# PIER 70 MIXED-USE DISTRICT PROJECT

**CITY AND COUNTY OF SAN FRANCISCO  
PLANNING DEPARTMENT: CASE NO. 2014-001272ENV  
STATE CLEARINGHOUSE NO. 2015052024**

DATE: August 9, 2017  
TO: Members of the Planning Commission and Interested Parties  
FROM: Lisa Gibson, Environmental Review Officer  
Re: **Attached Responses to Comments on Draft Environmental Impact Report Case No. 2014-001272ENV: Pier 70 Mixed-Use District Project**

# PIER 70 MIXED-USE DISTRICT PROJECT RESPONSES TO COMMENTS

**(NEW) FIGURE 4.D.2A: 1900 SANBORN FIRE INSURANCE CO. MAP**

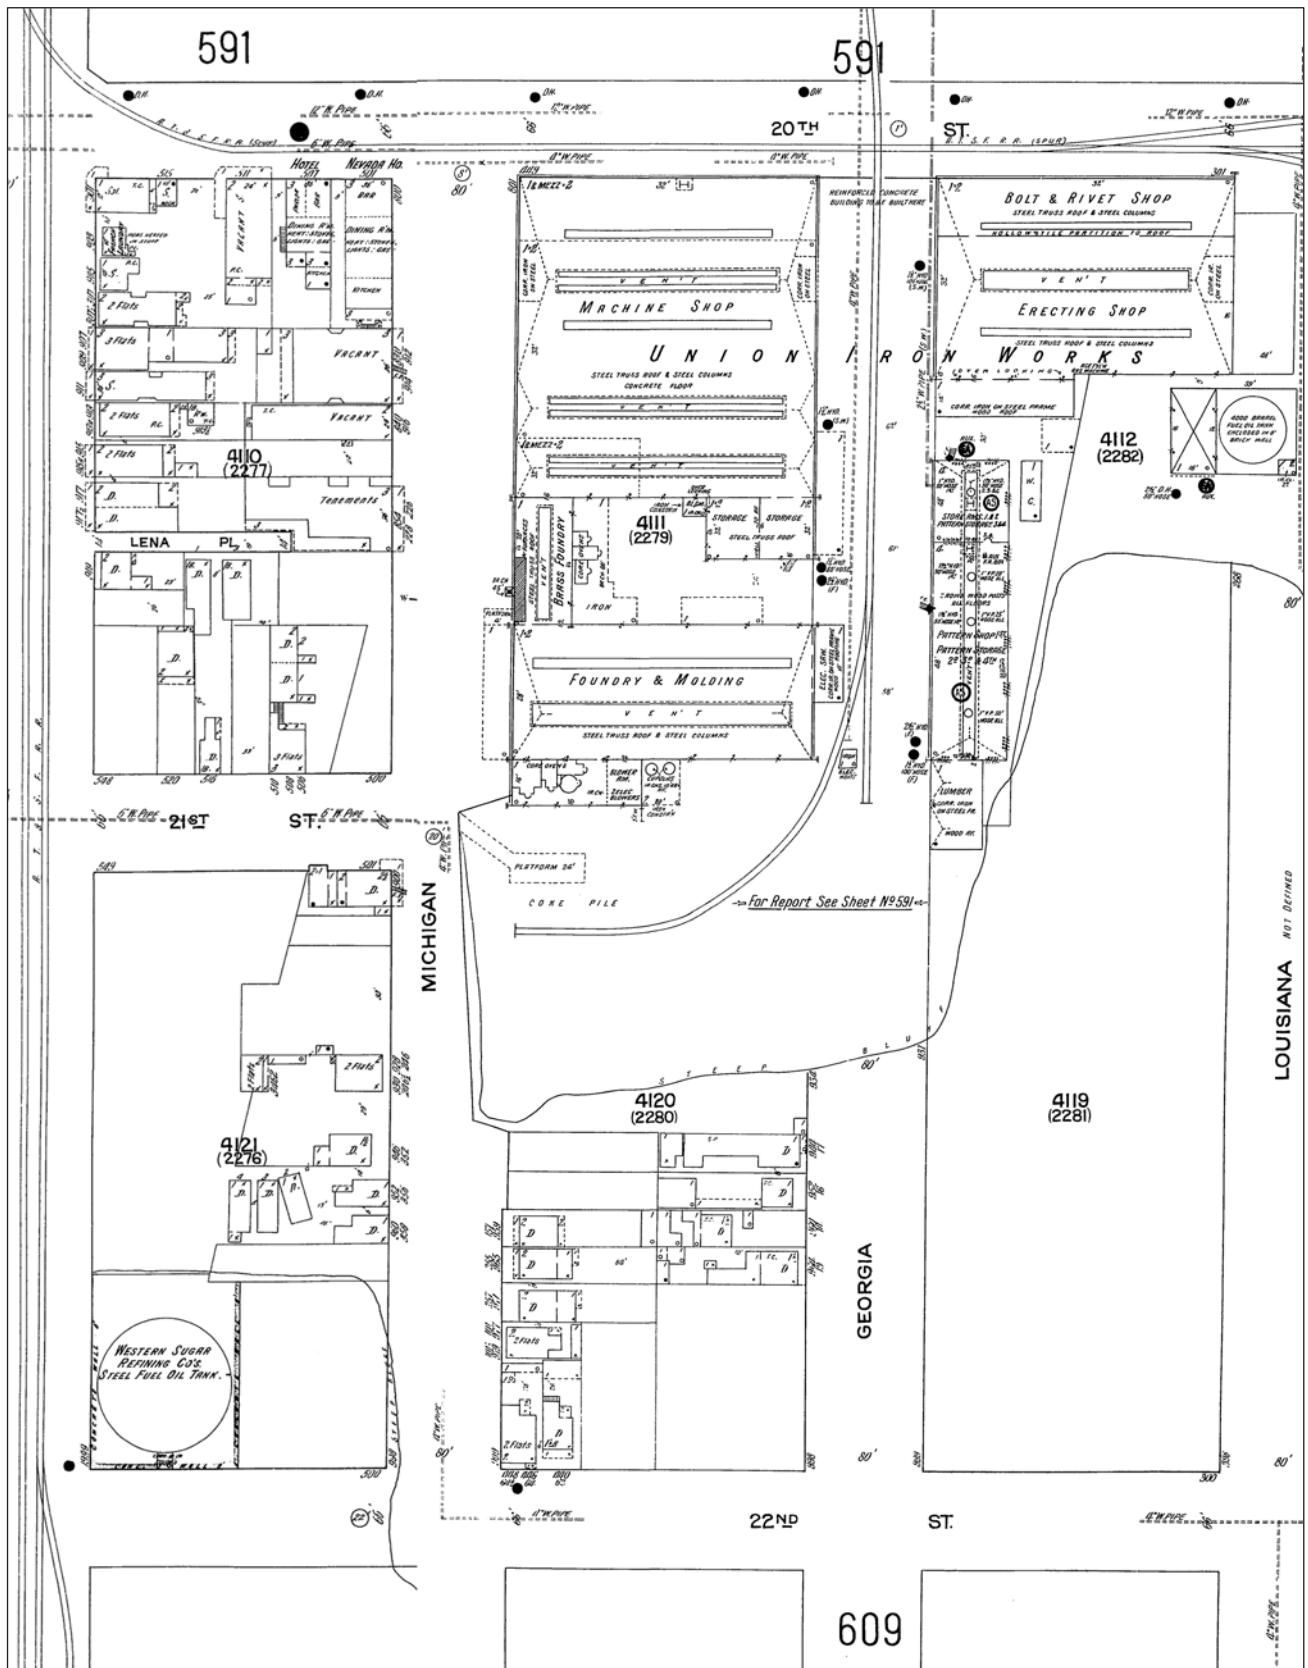
See Figure 4.D.2a: 1900 Sanborn Fire Insurance Company Map, in which multiple 1900 Sanborn maps are stitched together. These streets, which extended the block pattern established west of Illinois Street, appear to have in fact been interrupted by the steep banks of Irish Hill, with development to the north and south of the incline. The east end of 21<sup>st</sup> Street terminated at Michigan Street and was not extended into the site. At the time, Irish Hill hosted a small neighborhood. A mix of lodging houses, dining rooms, and saloons were located near 20<sup>th</sup> Street in the northern half of the block between Illinois and Michigan streets, while small single-family dwellings were clustered near 22<sup>nd</sup> Street in the two blocks bound by Illinois, Michigan, and Georgia streets.

The following text and additional figures have been added to the end of the discussion of “Historic Context” (EIR pp. 4.D.36-4.D.41), beginning on EIR p. 4.D.41, to provide the public with additional informational context by which to understand the impact of the proposed street pattern on the UIW Historic District (new text is underlined). New Figures 4.D.2a through 4.D.2e are shown on RTC pp. 5.59-5.60 and 5.62-5.64.

(NEW) FIGURE 4.D.2C: 1938 AERIAL PHOTOGRAPH OF SITE

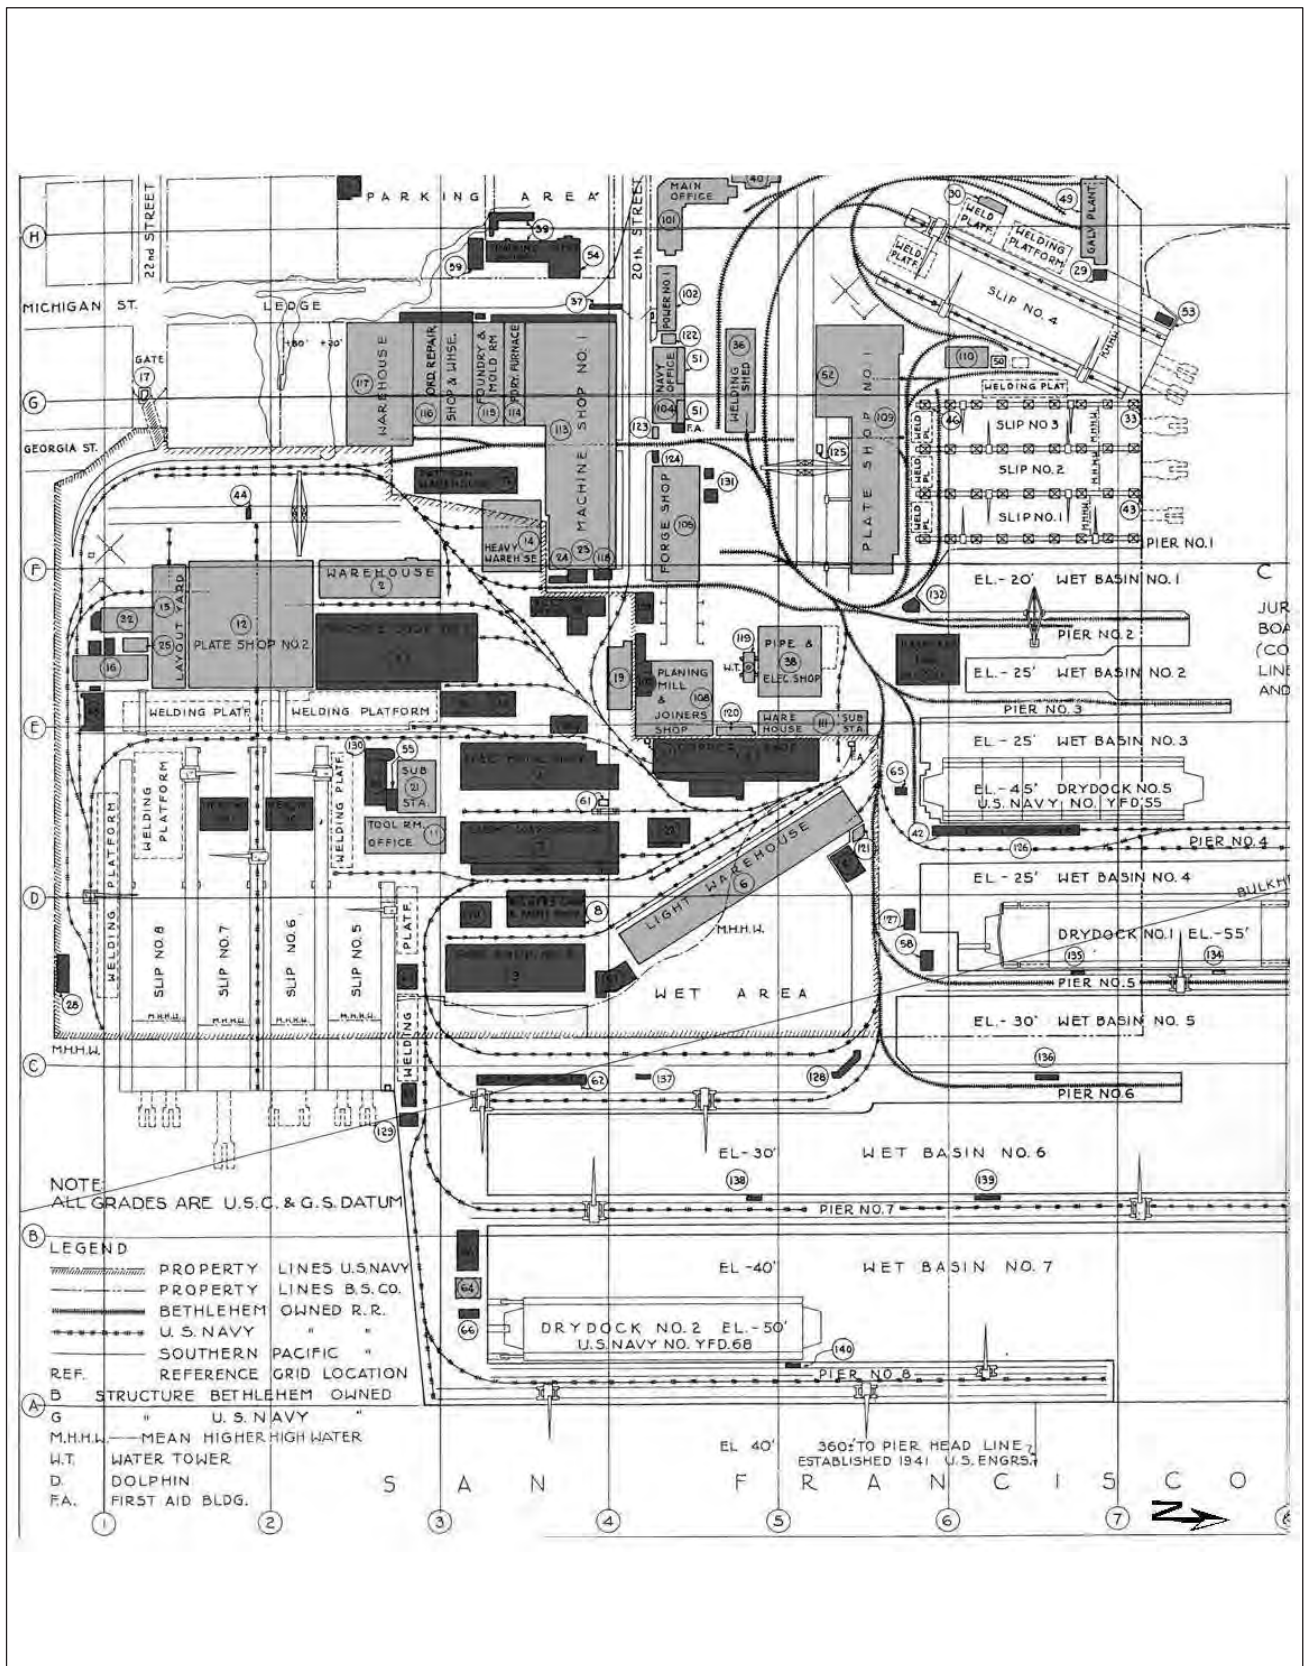
The 1938 aerial of the site, Figure 4.D.2c: 1938 Aerial Photograph of Site, shows the District immediately prior to its World War II-era build-up.<sup>17A</sup> By this time, little reference remained to the “state” streets east of Illinois Street. The northern portions of Michigan and Georgia streets had been reduced to small segments immediately east and west of the Buildings 113-116 complex, while Louisiana and Maryland streets were used for site circulation and largely given over to railroad tracks.

Before - 10 Turner Terrace aprox. 155 feet elevation

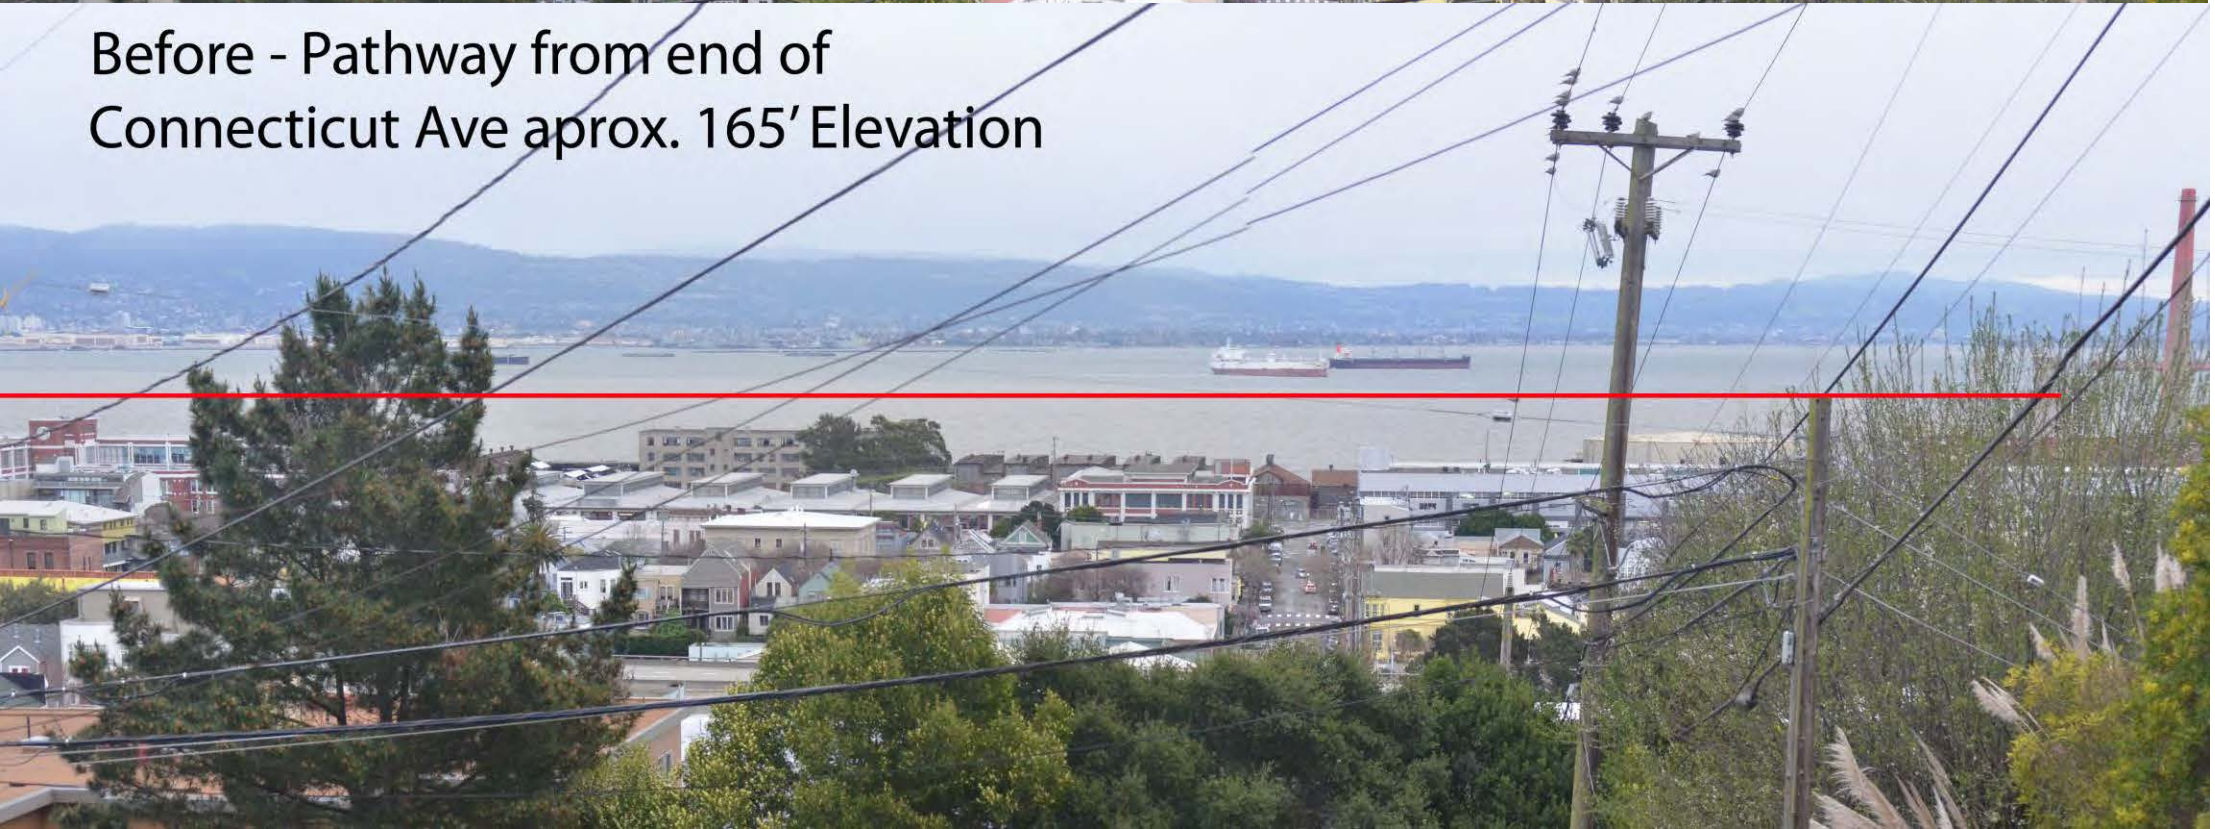
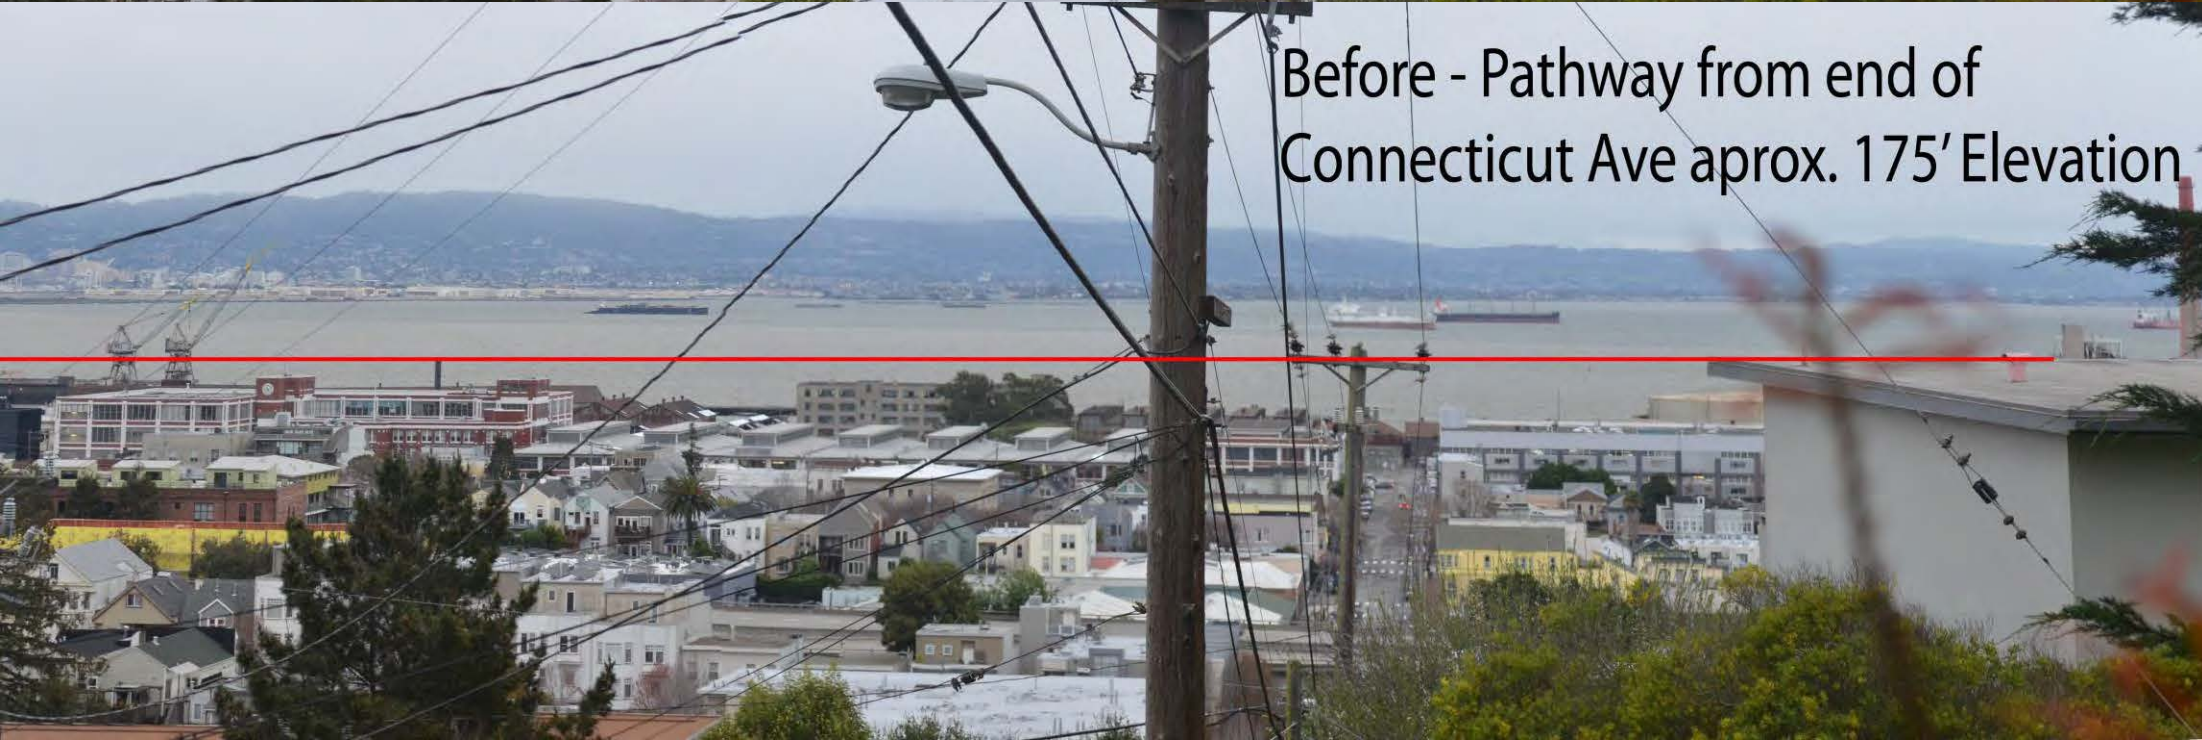
After - Pathway from end of Connecticut Ave aprox. 165' Elevation

After - Pathway from end of I-C&D Clark2  
Connecticut Ave aprox. 175' Elevation

Before - Pathway from end of  
Connecticut Ave aprox. 175' Elevation
